**ISSUE:** Certificate of Appropriateness for after-the-fact alterations

**APPLICANT:** Amanda Cernik

**LOCATION:** Parker-Gray District  
221 North Patrick Street

HOUSE LOCATION SURVEY ON THE  
**DAVID P. ANDROSS**  
**PROPERTY**  
DEED BOOK 847, PAGE 277  
CITY OF ALEXANDRIA, VIRGINIA

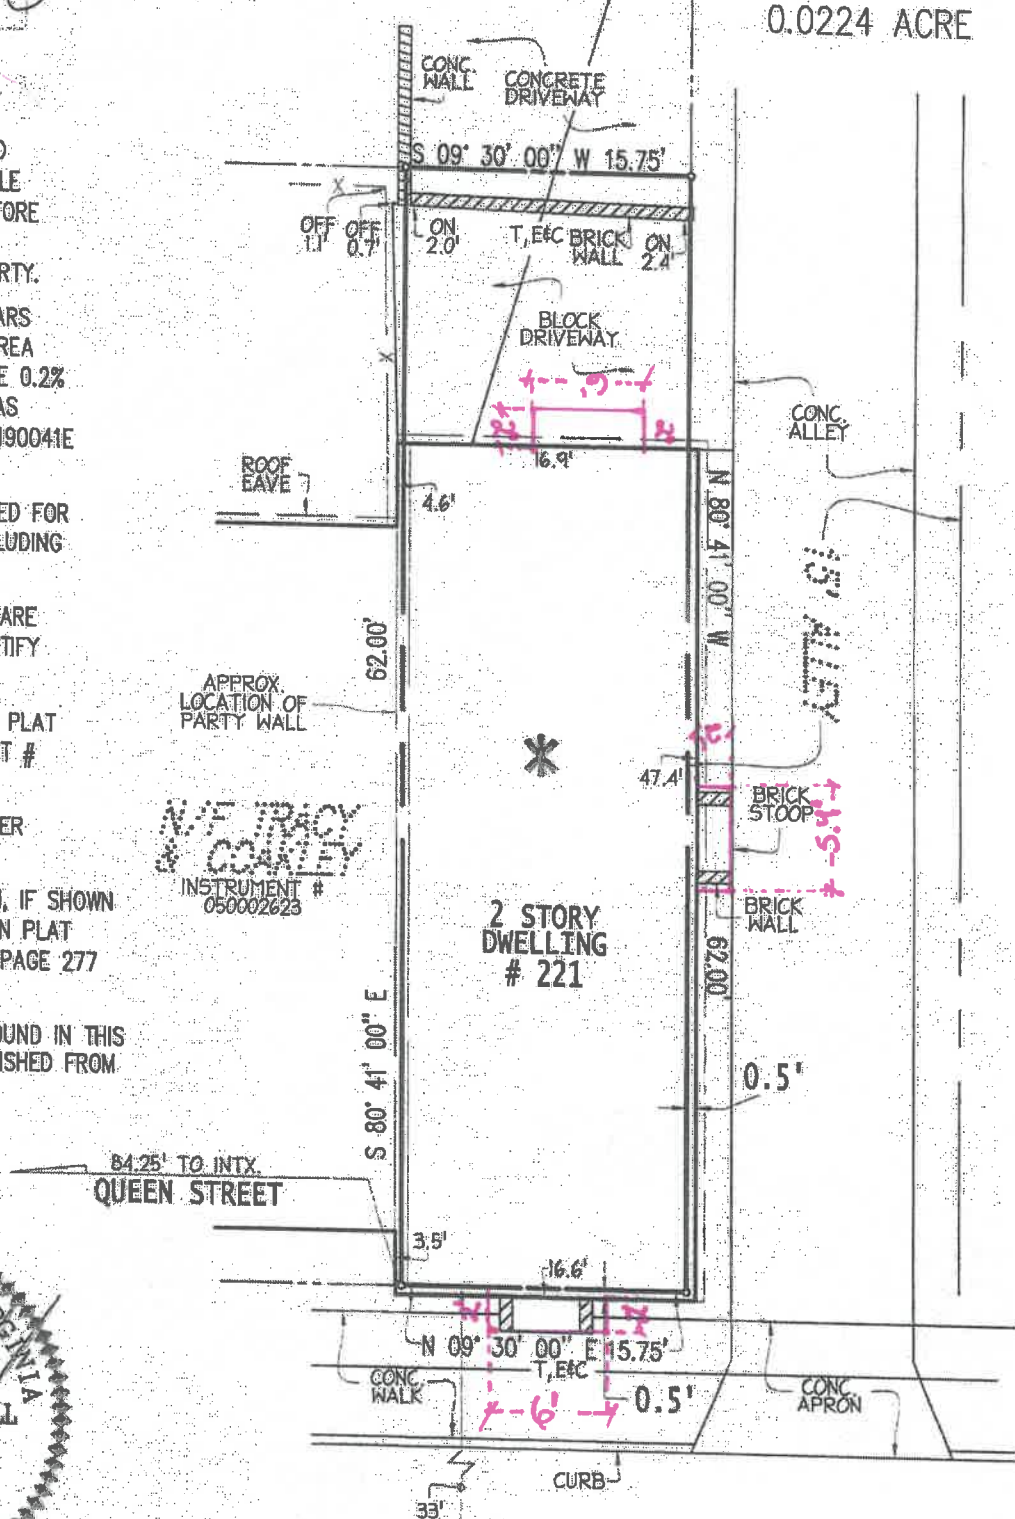
- C-2 The proposed area shown on the submitted plat as "block driveway" was used as a fenced in back yard until at least 2012 (based on images available in pictometry) and would have counted towards the 800 square feet of required open space. Required open space cannot be reduced without approval of a variance by the Board of Zoning Appeals. The pavers can remain in the rear yard, but it cannot be used as parking. Plat submitted has been reduced and is no longer to scale, so exact amount of provided open space cannot be calculated, but it appears to be well below the required 800 square feet. The covered rear entry will further reduce the open space and does not comply with zoning.

Existing house

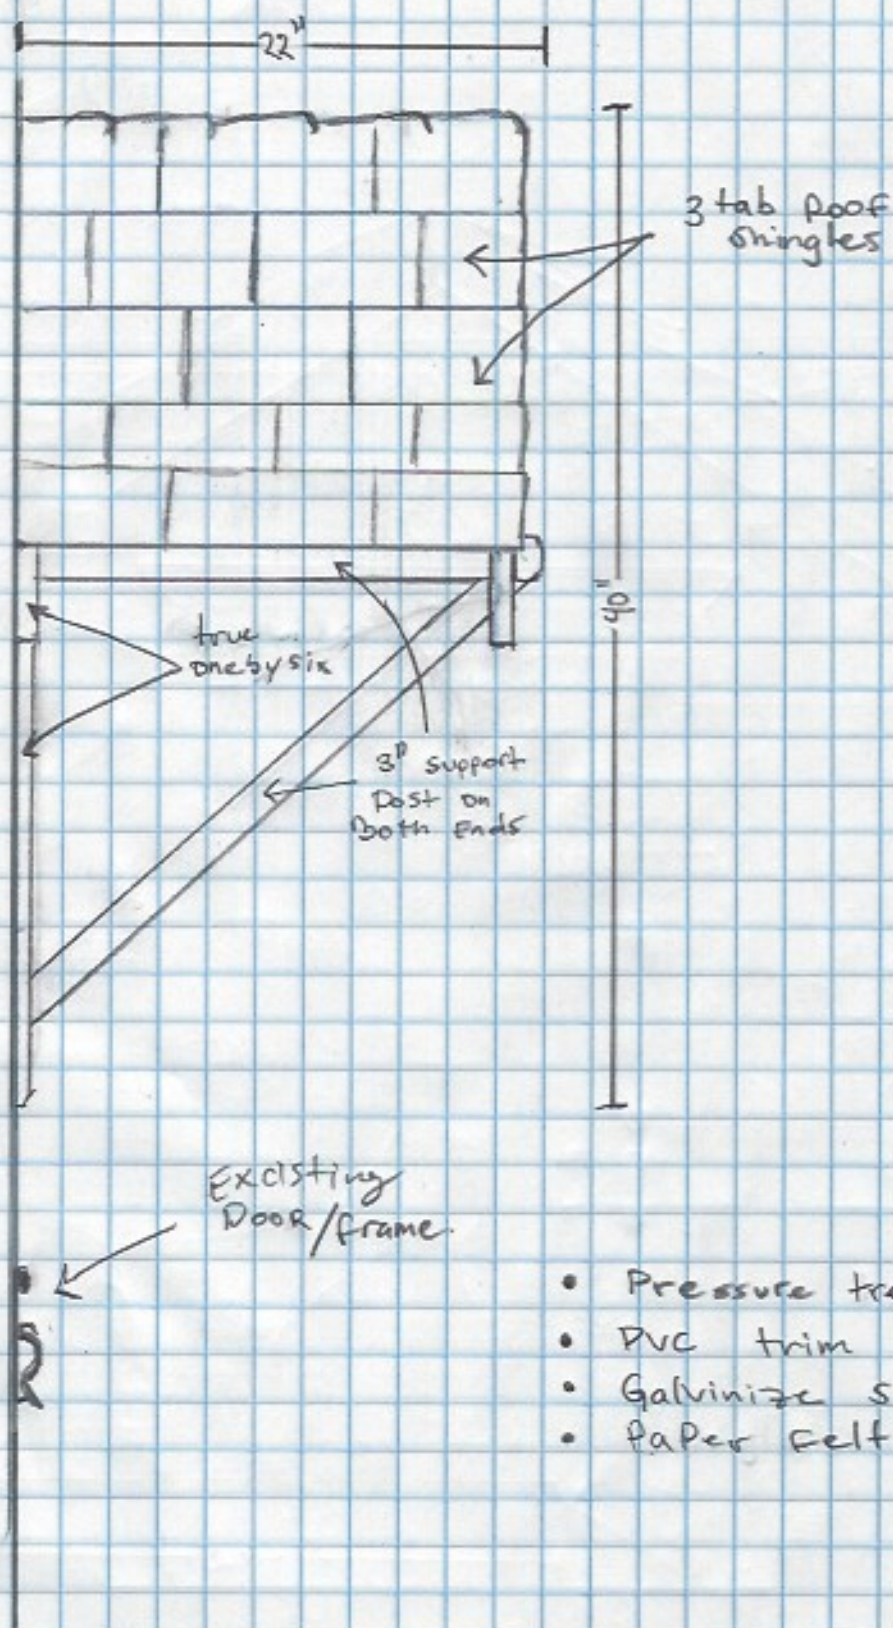
The composition shingle-roofed, front-gable entry canopies are supported by a pair of large triangular wooden knee-brackets attached to the wall. The bracket begins approximately five feet above grade and the lowest point of the rafter tails is 7'-5" above grade. Even though they appear to be well constructed and attractive in their own right, staff cannot support the after-the-fact Certificate of Appropriateness because:

way. While the canopy is within the four foot projection allowed above a sidewalk, the knee-brackets and rafter tails extend well below the eight foot minimum height in both cases. Therefore, the canopy over the front door could be exempt from the requirement for an encroachment if the brackets were removed and the rafter tails cut to a minimum of 8' above the sidewalk grade, though this would likely have an adverse effect on the design and structure. The brick step and cheeks at the front door may encroach into the public sidewalk but the ones in the alley may not, as there is no exemption from an encroachment ordinance requirement for projections into a public alley for steps, canopies or permanent planters. Staff will likely not support such a request because of a safety concern for utility vehicles and trash trucks that use these public alleys. Staff recommends that the alley canopy, stoop, step and planter all be removed.

1. Denial of a Certificate of Appropriateness for the existing door canopies on the west and south elevations. If the existing canopies are found by the BAR to be appropriate, the owner must obtain an encroachment ordinance from City Council.
